From: S Dunheimer sdunheimer@gmail.com  
Subject: Fwd: ERC - SP 2018-HM-024 Request for  
Date: 31 May 2019 at 18:08

Reviewing everything again, per the Chesapeake Bay Preservation Ordinance 118-1-9, maybe the more appropriate request would have been for the HVA to ask the "Director" to review the 12/18 RPA Delineation Study for accuracy vs. an ERC submission. I'm not quite sure who the "Director" would be, but would appreciate your assistance in determining if this individual would be the appropriate point of contact for submission of our questions and requests. **Specifically, we are focused on how the Ordinary High Water Mark was established for the 12/18 RPA Delineation Study.** We believe a request for review is warranted since this is such an environmentally sensitive lot, and the difference of approx 15' in this case could determine whether or not the applicant's proposed reserve drain field design will not only be 100% within an existing county-owned Conservation Easement, but also encroaching into the RPA.

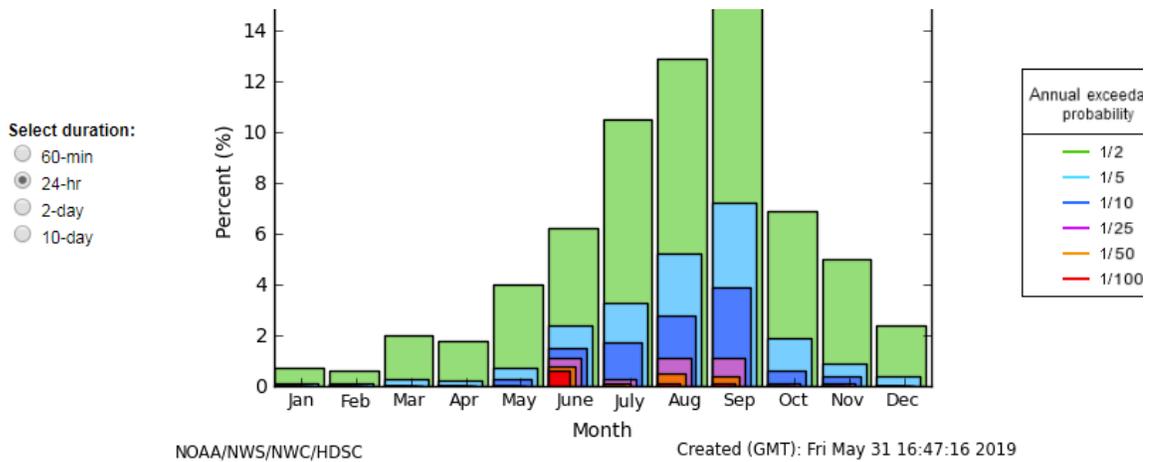
1) **The wetlands study indicates it was conducted 3/2017.** There are some sources that recommend doing this type of study during the June-Sept months for the most accurate data. We have also seen significant changes recently in our weather patterns that have produced many high-water marks not seen previously seen by area residents.
